RE: Horsley Logistics Park Stage 2 (SSD-71144719) | Fire Brigade Access Review

BCA Compliance Review – Fire Brigade Access

Figure-1: Vehicular Perimeter Access Road and Identified Areas of BCA Non-Conformance

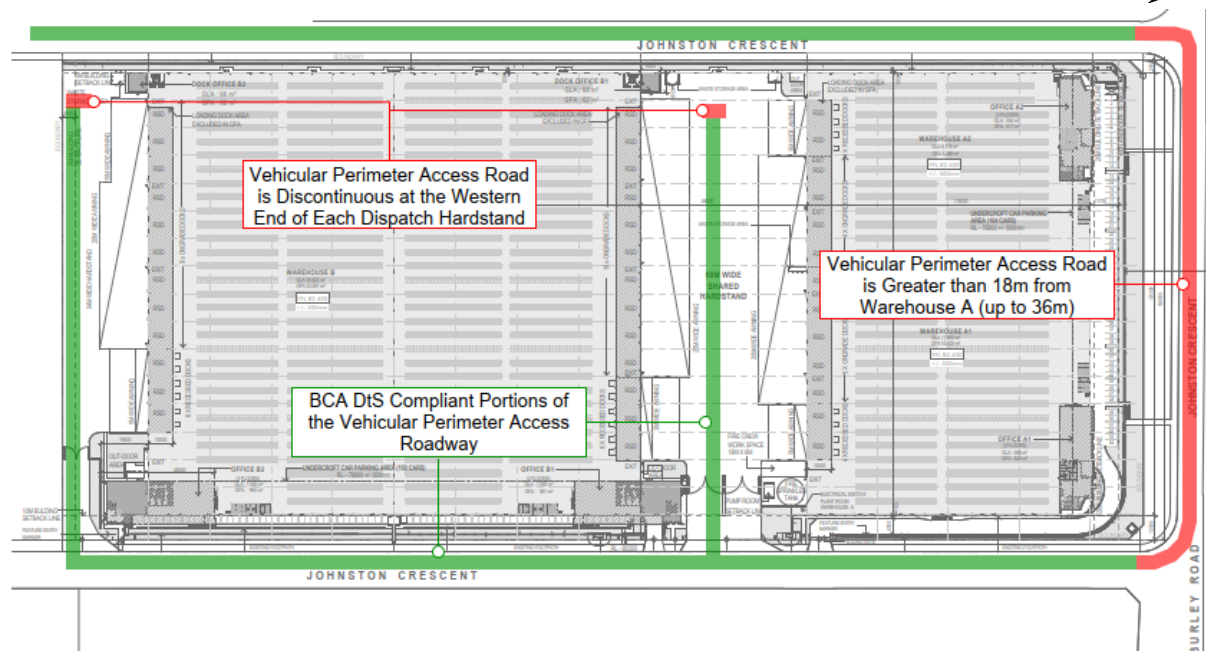
The review has identified the areas of non-conformance detailed within Table-1 and as illustrated in Figure-1.

Regulatory Clause/ Performance Requirement	Regulatory Variation
Perimeter Vehicular Access	<ul style="list-style-type: none">▶ Clause C3D5(2)(a): The vehicular access road is discontinuous in the following locations –<ul style="list-style-type: none">○ the western end of the southern dispatch hardstand; and○ the western end of the central dispatch hardstand.
BCA Clause C3D5	<ul style="list-style-type: none">▶ Clause C3D5(2)(b): The vehicular access road navigates more than 18m from the building in the following locations –
Performance Requirement C1P9	<ul style="list-style-type: none">○ Around the northern side of the site, along Johnston Crescent, where the roadway is 36m from Warehouse A.

A fire engineered Performance Solution will be developed ahead of the relevant Construction Certificate and subject to FRNSW approval through the Fire Authority referral pathway detailed within the Environmental Planning and Assessment (Development Certification and Fire Safety) Regulation 2021.

The Performance Solution will specifically address the variation from the prescriptive BCA DtS provisions listed in Table-1; noting that a Performance Solution is permitted within Sections 10.2.4 and 10.2.6 of the FRNSW Fire Safety Guideline "Access for fire brigade vehicles and firefighters [1].

Figure-2: Fire Fighter Access Stairs from Johnston Crescent

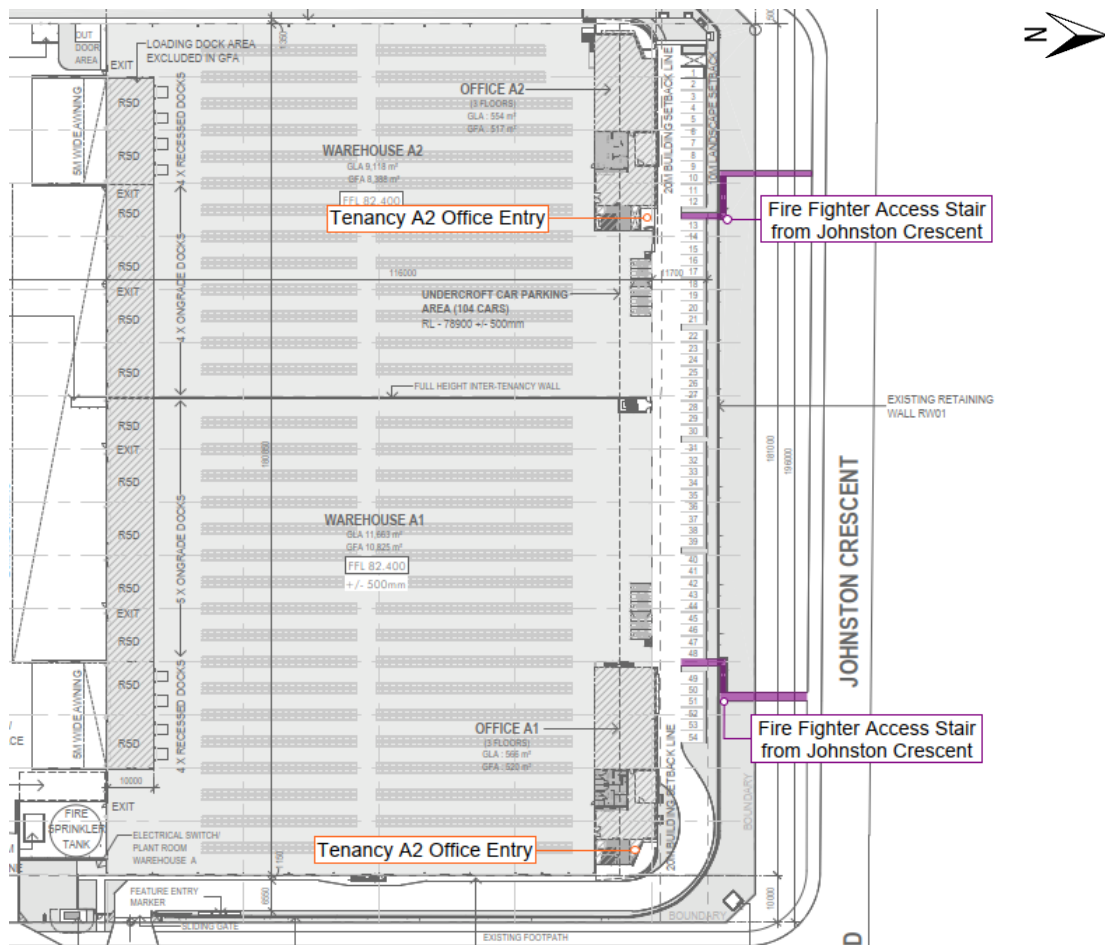
While this setback is not significant or excessive relative to a DtS scenario, the landscape and staff carpark between Johnston Crescent and Warehouse A presents a challenge for fire fighter access due to the carpark being elevated by approximately 3.5m above Johnston Crescent and a site security fence separating the two locations. On account of the above the fire strategy incorporates:

- ▶ Two (2) additional pedestrian stairs to enable access between Johnston Crescent and the external carpark where fire hydrants and entry doors into Warehouse 1A and 1B are located.
- ▶ Given the two additional stairs are dedicated to FRNSW use, gates within the security fence shall be padlocked with 003 keys to ensure unrestricted fire fighter access.

The pedestrian stairways are defined in Figure-2. The stair locations have been strategically located to ensure an external hydrant would be accessible within 50m of Johnston Crescent as required in the FRNSW Guideline (Clause 8.2.1) and the Australian Standard for fire hydrant system design, AS2419.1:2021 (Clause 3.5.3.3(a)(i)).

Figure-4: Fire Brigade Appliance Turning Sweep Path Diagrams at the Southern and Central Hardstands

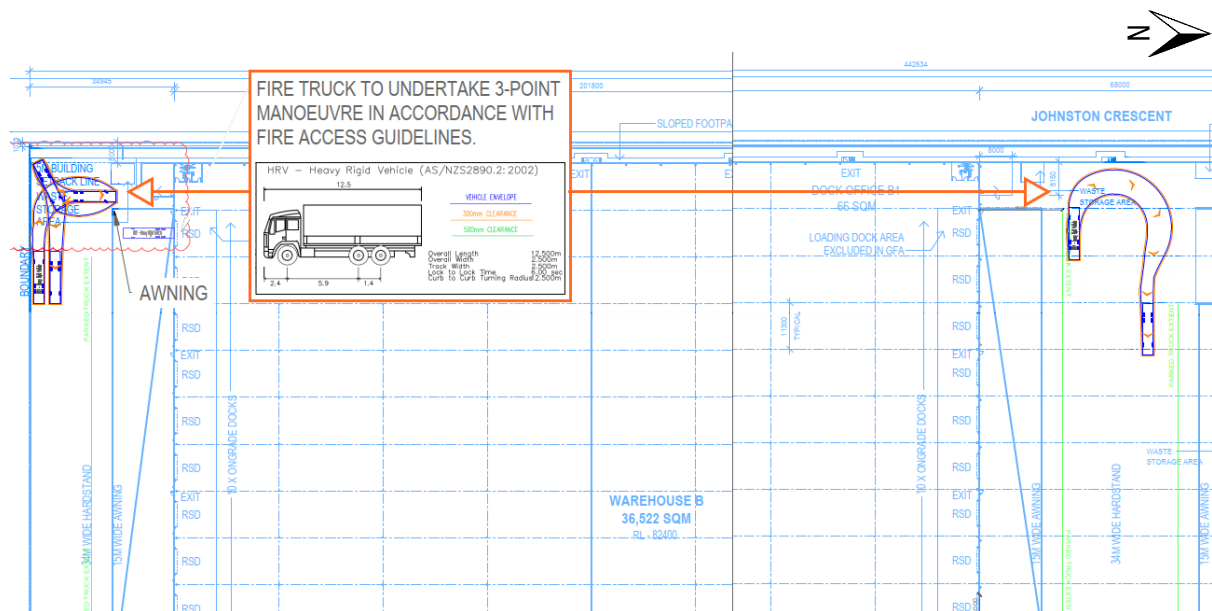
In this design a continuous roadway is predominately provided, with the exceptions being the western ends of the two (2) dispatch hardstands where there is a change in level between the dispatch hardstands and Johnston Crescent to the west.

A continuous vehicular travel path is important to fire brigade intervention as it allows fire fighter vehicles to quickly travel away from an immediate place of danger should there be a potential risk to safety. Potential risks may include a fire spreading to their location, structural collapse that may impact the access road, or a change in the wind direction where smoke moves to their location.

- ▶ The dispatch hardstands have been sized to ensure there is ample room for FRNSW appliances to undertake a quick manoeuvre to turn around and exit the site if deemed necessary.

Detailed sweep path diagrams were prepared as part of the original design and presented below in Figure-4.

As illustrated above, by allowing an appliance to turn around with relative ease, fire fighters can position their appliance in an arrangement that it is pointing towards the site's exit prior to setting up any equipment or deploying the aerial appliance stabilisers. Therefore, when an emergency arises, the vehicle can quickly exit from the location with minimal delay to meet the operational needs of FRNSW while ensuring operator safety.
